## **PROPOSED TRAFFIC LINK**

## **LAXON TERRACE – FURNEAUX WAY**

## **TRAFFIC SAFETY REVIEW**

**October 2012**  
**Reference: 12252**  
**Issue B**

Figure 8 – Furneaux Way Visibility

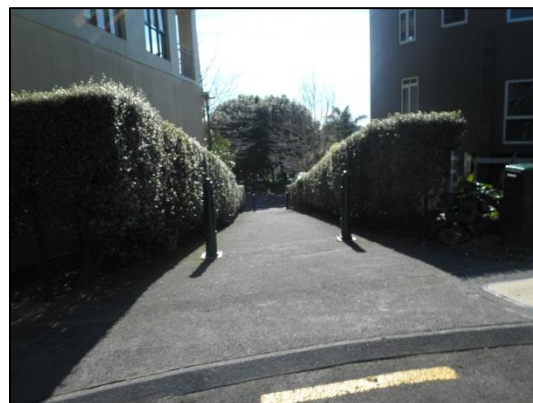
Drawing sheet 2 indicates that the Furneaux Way entry into the one lane link will be controlled by give way control. But from a point 9 metres back from the limit line, visibility of traffic on the one-lane link is restricted by a vertical crest curve where Furneaux Way meets the one lane link. The restricted visibility may make it unsafe to approach the intersection at a speed greater than 10 km/h<sup>1</sup> as shown in Figure 8.

<sup>1</sup> Note: It is unsafe to approach an intersection at more than 10 km/h if, a driver cannot see a vehicle on an uncontrolled approach at a distance (metres) of 1.2 times the speed (km/h) exceeded by 15% of vehicles on the priority route.

*Check if the visibility on the Furneaux Way entry into the one lane link is sufficient to allow the one lane link to be safely approached at a speed greater than 10 km/h as per Section 6 of Part 1 of the Manual of Traffic Signs and Markings. If it is not, either*

- install stop control on the Furneaux Way entry into the one lane link; or*
- remove the crest to improve the visibility from the Furneaux Way entry of traffic on the one lane link.*
